**CITY OF TEMPE  
DEVELOPMENT REVIEW COMMISSION**

**ACTION:** Request for a Use Permit Standard to increase the maximum building height from 30' to 33' and a Development Plan Review consisting of eight new townhomes for **HARDY TOWNHOMES**, located at 506 South Hardy Drive. The applicant is Earl, Curley & Largarde P.C.

**BACKGROUND INFORMATION:** **HARDY TOWNHOMES (PL150108)** is a proposed eight lot townhome development. The request includes the following:

**sheet No:** SP 100

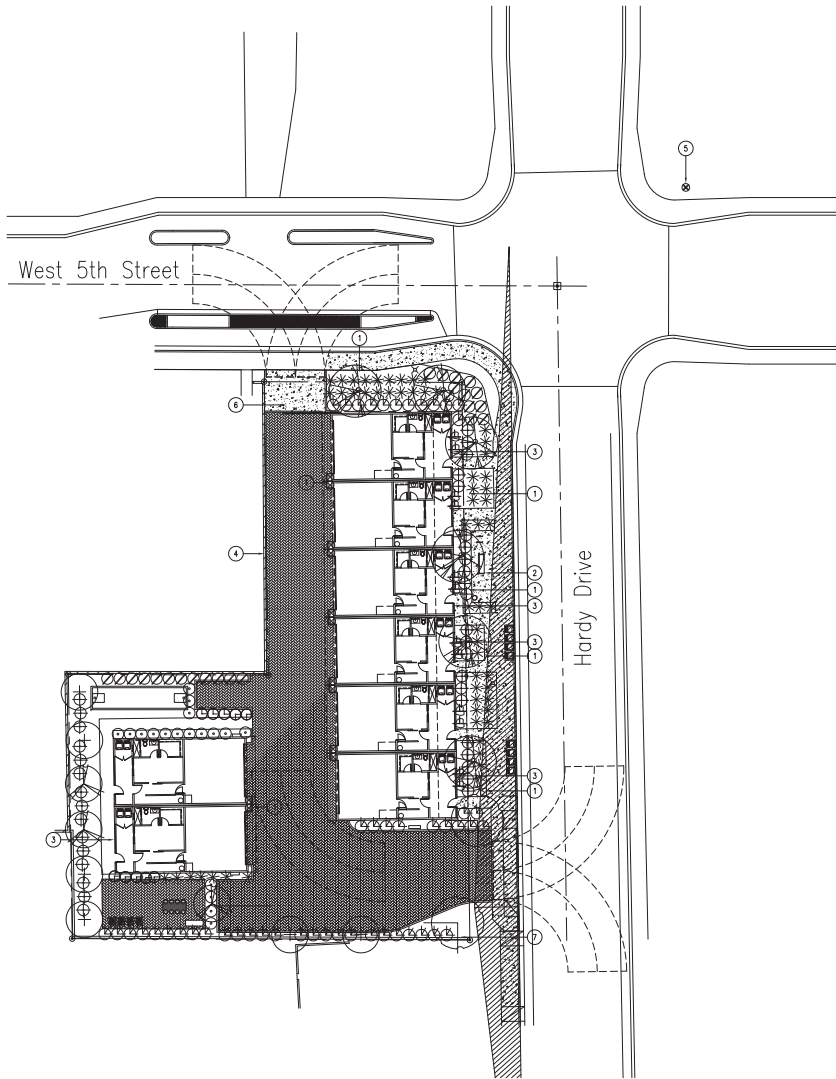
- 4/8/2015: First Preliminary Site Plan review was completed (site plan only). Plan identified eight units in two buildings. Comments made by staff included: identify proposed locations of refuse pick-up on Hardy Drive, provide a 6' sidewalk on Hardy; provide landscape planters between garage doors along private drive, use pavers or stamped concrete on private drive, and provide correct driveway dimensions and fire truck turning radii.

- 8/13/15: Second Preliminary Site Plan review was completed. Comments made by staff included: identify proposed locations of refuse pick-up on Hardy Drive; replace wood perimeter fence with new CMU wall and provide a wall along south property line; note treatment of existing CMU walls to remain (stucco and paint); recess windows for shade; provide shade elements over entry doors; reduce amount of paving along Hardy by narrowing paths leading to private patios; and provide correct driveway dimensions and fire truck turning radii. Prior to formal submittal, applicant worked with staff to create solution to refuse bin pick-up locations.

- 9/30/15: Formal applications were submitted and a third Site Plan Review was completed. Staff comments included: construct a new CMU wall along south boundary of property; note treatment of existing CMU walls to remain; reduce amount of paving along Hardy by narrowing paths leading to private patios; show proposed townhome property lines; reduce patio wall heights from 8' to max. 6'; enclose patios along Hardy to provide privacy and replace green screen with more decorative material; replace proposed dark gray trex with a lighter brown color; address blank walls of Building B north and south elevations; provide minimum clearance inside garages of 21' wide by 20' deep; and provide correct driveway dimensions.

- 10/21/15: Fourth Site Plan Review was completed. Staff comments included: construct a new CMU wall along south boundary of property; reduce amount of paving along Hardy; reduce patio wall heights from 8' to max. 6'; enclose patios along Hardy to provide privacy and replace green screen with more decorative material; address blank walls of Building B north and south elevations; provide vining plants adjacent to patio walls/fences; provide correct driveway dimensions; provide 6' wide sidewalk on Hardy;

4. Utility equipment boxes for this development shall be finished in a neutral color (subject to utility provider approval) that compliments the coloring of the buildings.
5. Place exterior, freestanding reduced pressure and double check backflow assemblies in pre-manufactured, pre-finished, lockable cages (one assembly per cage). If backflow prevention or similar device is for a 3" or greater water line, delete cage and provide a masonry or concrete screen wall following the requirements of Standard Detail T-214.

Sheet No: **A 100**

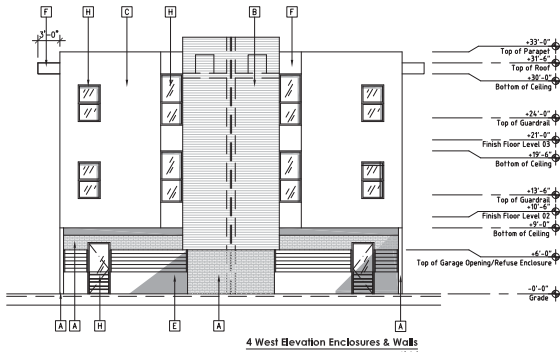
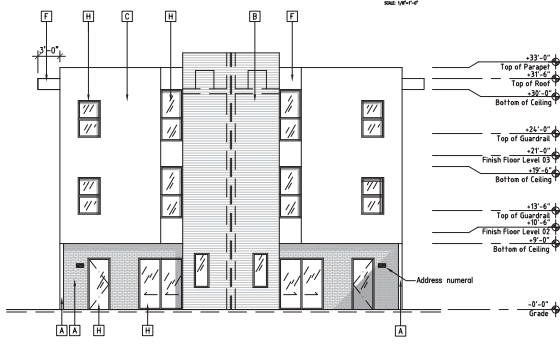
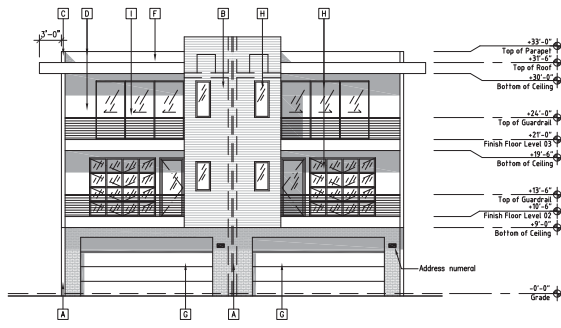
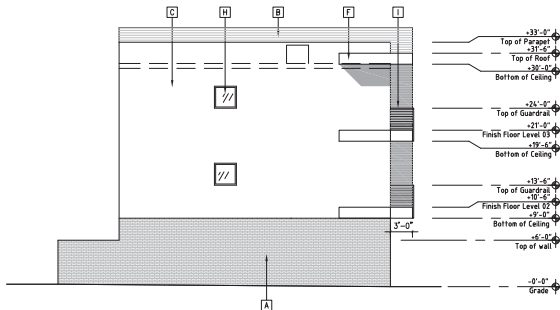
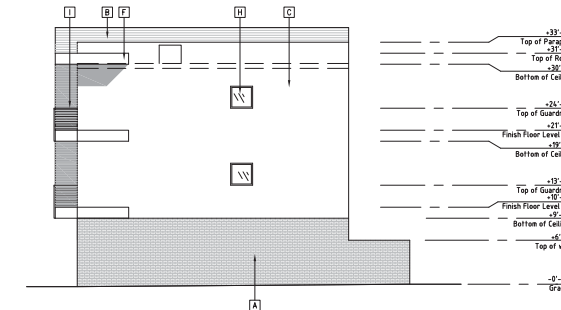
Patios on all floors are shaded by the floor of the patio above or by a steel canopy. First floor patios are enclosed by 3' high block walls with brick veneer that extends to 6' high in locations of the refuse bin storage areas. Beyond the bin storage areas, aircraft cable fencing is attached on top of the walls to secure the patios while allowing visual surveillance as well as a place for vining plants to grow. The material schedule on elevation sheets notes a height of 48" for this aircraft cable. A condition is included to limit the cable fencing to a maximum 36" for an overall patio wall/ fence height of 6'. The west elevation of Building A notes that windows are recessed 4", but the lack of a similar note and shading makes it unclear whether or not recessed windows are proposed on Building B. A condition is included that requires all windows on the south and west elevations to be designed with a 4" recess.

6. All windows on the south and west elevations of Buildings A and B shall be recessed a minimum of 4".
7. Reduce the height of the aircraft cable above the solid walls at the first floor patios from 48" to 36".
8. The metal trim that extends from the second and third floor balconies on the north and south elevations of Building B shall be mounted flush with the building wall.
9. Provide secure roof access from the interior of the building. Do not expose roof access to public view.
10. Conceal roof drainage system within the interior of the building.
11. Incorporate lighting, address signs, and incidental equipment attachments (alarm klaxons, security cameras, etc.) where exposed into the design of the building elevations. Exposed conduit, piping, or related materials is not permitted.
